Planning & Zoning Board Meeting
Town Hall - 8590 Park Drive Mount Pleasant, NC
Monday, October 26, 2026, 6pm

Sub 2026-02 Heritage Preserve Subdivision (Previously Heritage Creek)

To: Planning & Zoning Board
From: Erin S. Burris, AICP – Planning & Economic Development Director
Date: October 26, 2026
Subject: SUB 2026-02 Heritage Preserve Major Subdivision Preliminary Plat

Major Subdivision Preliminary Plat (Conservation Development)

COVER

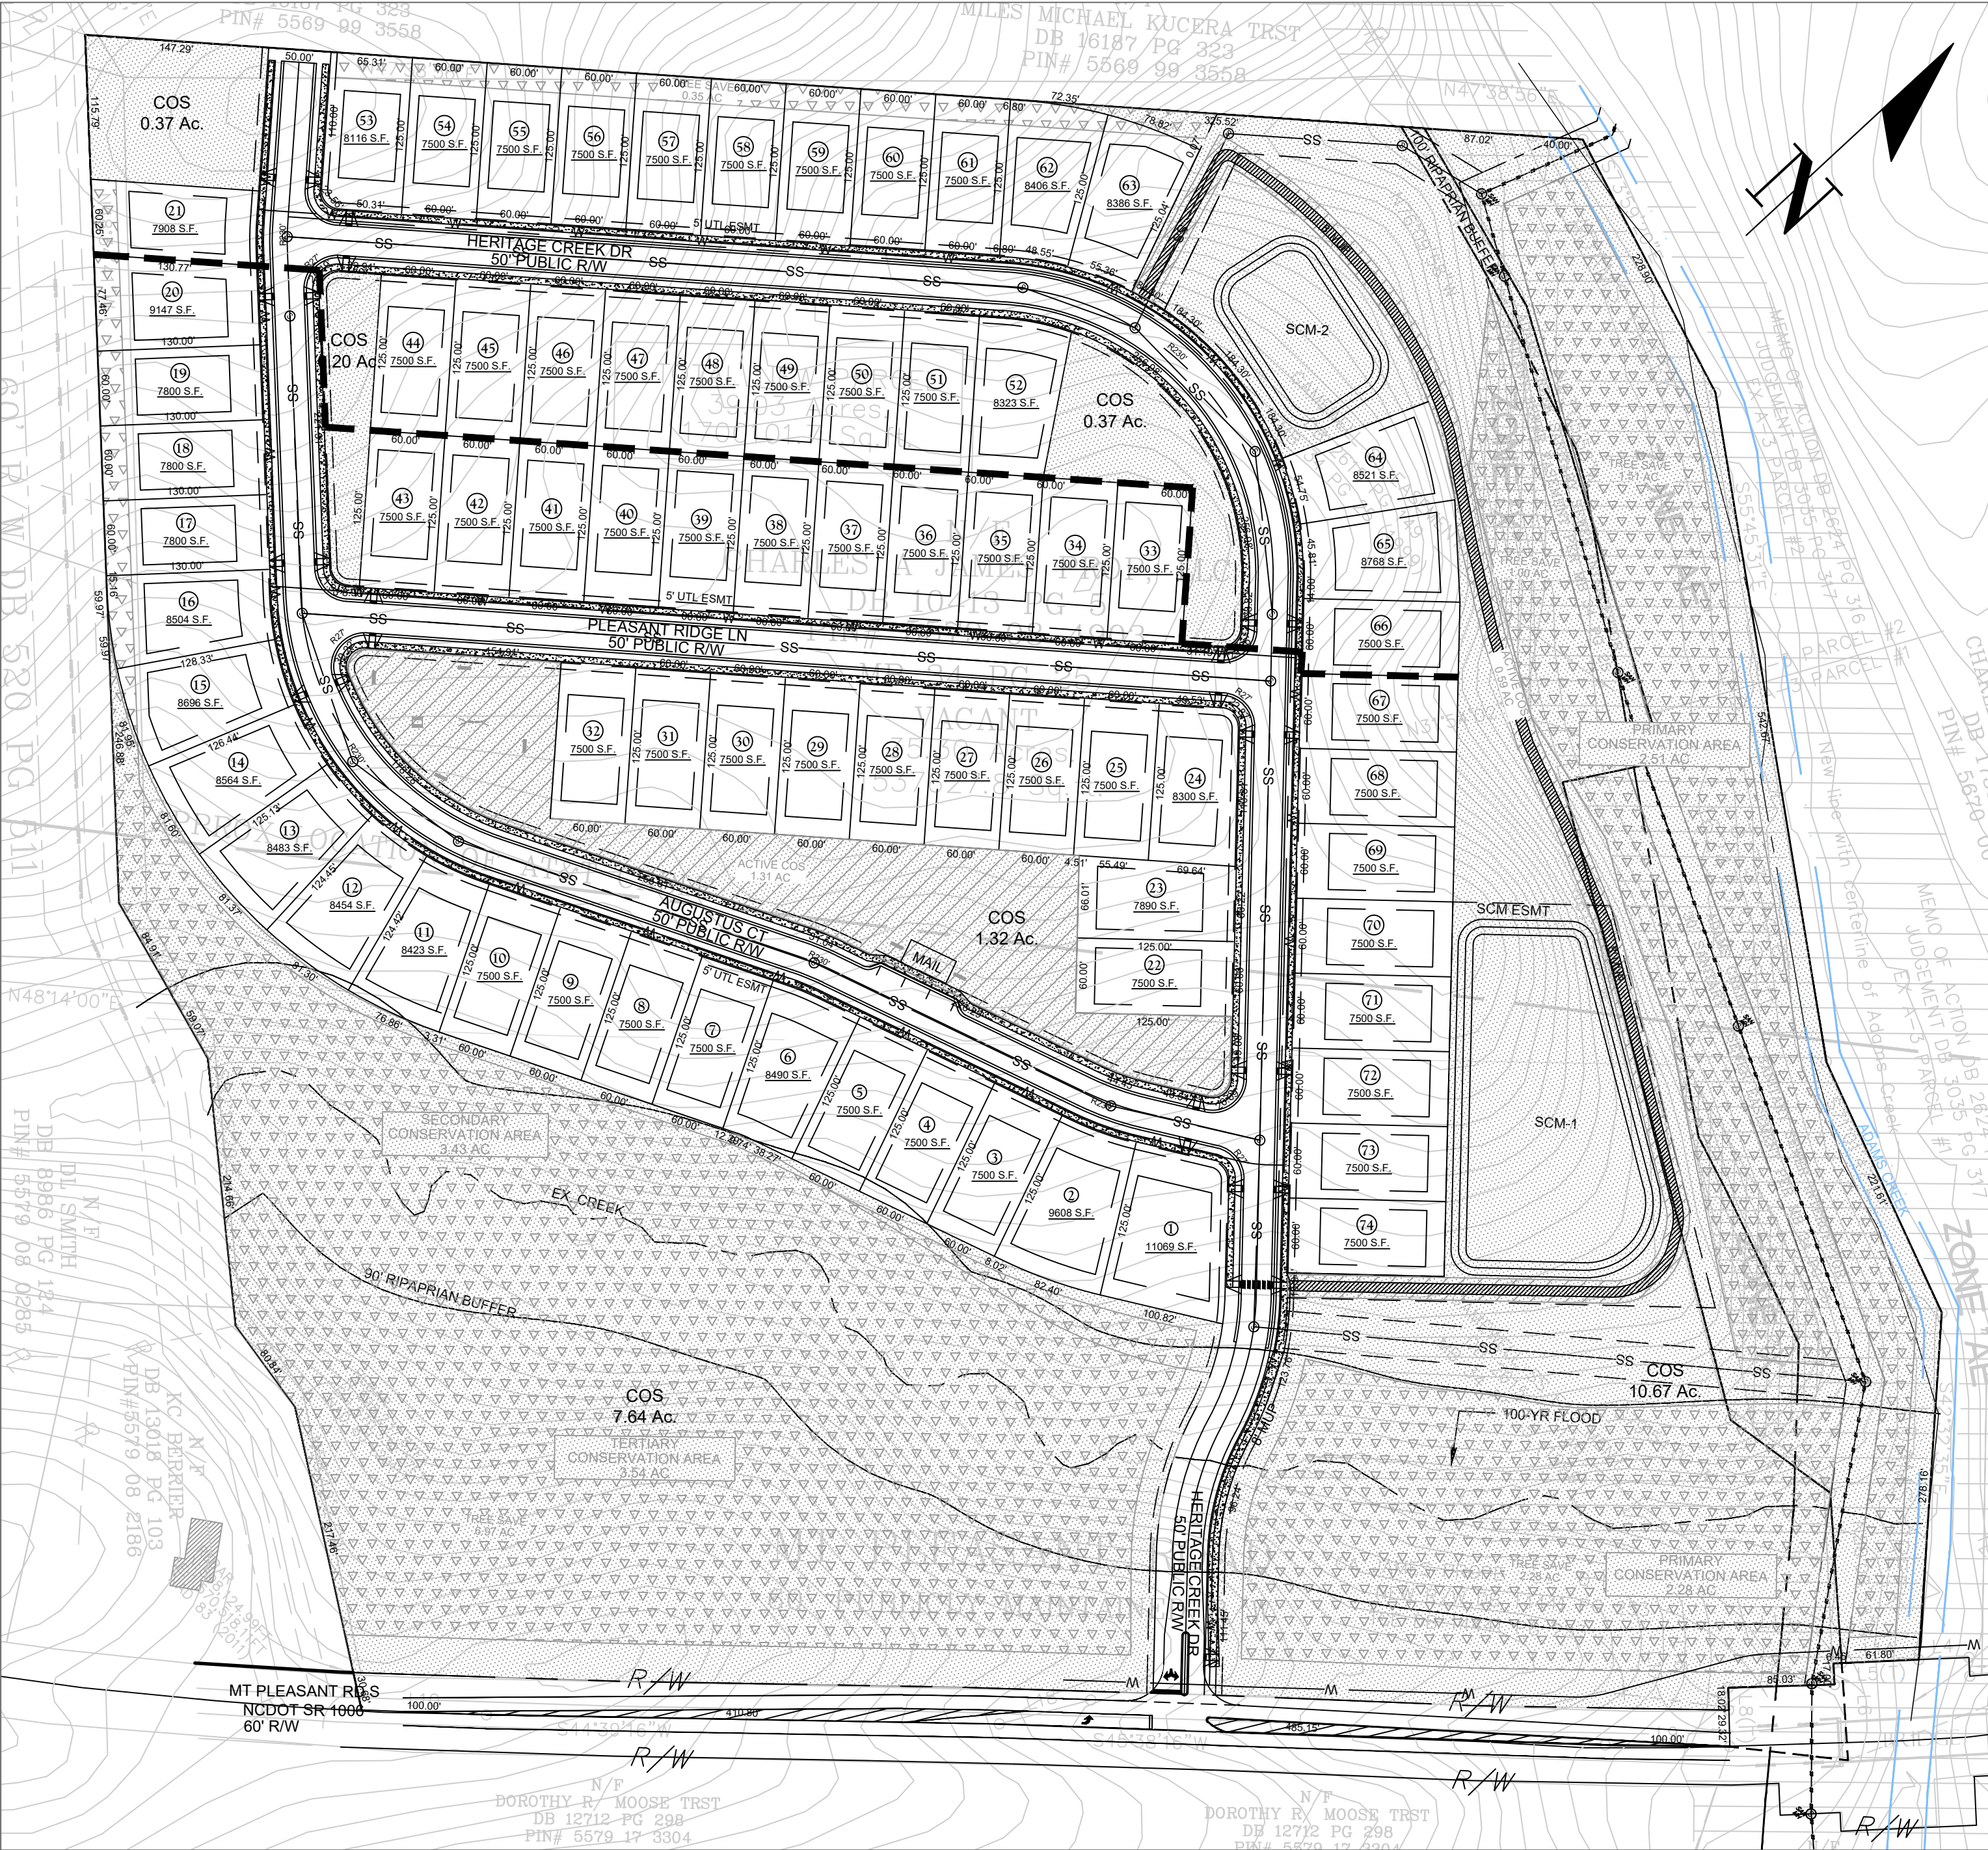
- MEET THE NCDOT AND TOWN'S STANDARDS.
- LANE WIDENING ON MOUNT PLEASANT RD S PER NCDOT STANDARDS.
- DRAINAGE WITHIN ROW - RCP PIPES (NO HDPE OR CMP), SOLID WALL CBS (NO WAFFLE BOXES).

- ENGINEER MAY WISH TO SPECIFY, BUT CONTRACTOR NEEDS TO INSTALL CORRECT GRATES ON CBS - TYPE E, F, OR G - SEE NCDOT 840.03.
- DRAINAGE BEHIND HOMES MAY BE RDGP, HDPE, OR PP. ALL EASEMENTS OUTSIDE ROW SHALL BE LABELED AS "PRIVATE DRAINAGE EASEMENTS".

- STORMWATER TO HAVE CCTV, LIKE SEWER. ALL LINES MUST BE CLEANED PRIOR TO CCTV.
- NO PARKING ON 24' WIDE STREET.
- ALL STORM DRAINAGE WITHIN THE ROW TO HAVE CCTV AND ENGINEER TO REVIEW AND HAVE CONTRACTOR REPAIR. SUBMIT FINAL CCTV TO TOWN FOR FINAL REVIEW.

- MINIMUM RADIUS AT CORNERS - 25' R AT BOC.
- ADA RAMPS TO AVOID LOT DRIVEWAYS.
- STORM SYSTEMS TO HAVE ADEQUATE EASEMENTS WIDTHS AS SHOWN IN DETAIL.
- CAN NOT DISCHARGE SCM OUTFLOW ACROSS SANITARY SEWER EASEMENTS WITHOUT CONTROLS & PROTECTION.

- FENCE AROUND SCM STRUCTURES. MINIMUM 48" HIGH
- WATER AND SEWER SERVICES TO BE 12" (MIN) TO 24" (MAX) APART IN THE CENTER OF THE LOT BEHIND THE SIDEWALK - WITHIN 12"-18" MAX; MINIMUM OF 5' FROM ANY DRIVEWAY AND 10' FROM LOT LINE.

- NO SERVICES SHOULD BE WITHIN A DRIVEWAY. IMPORTANT TO SHOW POSSIBLE DRIVEWAYS ON PLANS AND INSERT A SERVICE DETAIL SHOWING BOTH WATER METER AND SEWER CLEANOUT SIDE BY SIDE.

- MINIMUM FIRE FLOW IS 1,000 GPM. FIRE FLOW TESTING SHOULD BE PERFORMED BY THE DEVELOPER. RESULTS SENT TO TOWN AND PART OF ENGINEER'S REPORT TO PWS.
- DEVELOPER WILL BE REQUIRED TO BORE UNDER CREEK AT BRIDGE WITH CASING. WATER MAIN SHOULD RJ-DIP. MAY HAVE TO OBTAIN PERMANENT EASEMENTS.

- 6" & 8" MAINS - PVC C900 SDR 14 (PC 305 PSI) OR DIP
- 2" MAIN - PVC SDR 13.5 (PC 315 PSI)
- MAINS BEDDED IN NATURAL DIRT, SAND, OR #78M STONE - NOT ON ROCK.

- STORZ CONNECTION ON HYDS; HYDS TO BE PLACED 3' BEHIND C&G.
- HYD LAYOUT TO BE AT CORNERS AND SPACED AT 400'±.
- HYDS TO BE PAINTED TRAFFIC OR SAFETY YELLOW.

- OFF-STREET SEWER OUTFALL TO HAVE A 30-FT PERMEANT SANITARY SEWER EASEMENT.
- 8" PIPE - PVC SDR 26, FULLY BEDDED IN #57 OR #67 STONE, 4" ALL AROUND PIPE MINIMAL AND OVER, COMPACTED ON SIDES.

- MHS TO HAVE A STANDARD 0.20' DROP THROUGH INVERT. NO PIPE SPILLING INTO MANHOLES. OUTSIDE DROP MHS TO BE A MINIMUM OF 30" HIGH. PREFER 4-INCH LATERALS NOT SPILL INTO MHS EITHER. CORE MH AT SHELF LEVEL FOR LATERALS.

- SEWER MAINS AND LATERALS TO BE LOW PRESSURE AIR TESTED, MANDREL TESTED (MAINS), VACUUM TESTED (MHS) AND CCTV; ENGINEER TO PROVIDE THE TOWN WITH COPIES AND CERTIFICATION OF ALL TESTING.

- ENGINEER TO REVIEW CCTV AND HAVE CONTRACTOR MAKE ALL REPAIRS AND RE-CCTV. SUBMIT FINAL CCTV TO TOWN FOR REVIEW.
- LATERALS - PREFER MINIMAL GRADE TO BE 2% TO CO

- LATERALS NEED TO HAVE A COMPACTED FOUNDATION TO AVOID SAG AS A RESULT OF OVER EXCAVATION AND COMPACTED BACKFILL.
- THE BERM MUST BE COMPLETELY OUTSIDE OF ANY SEWER EASEMENT FOR SAFETY.
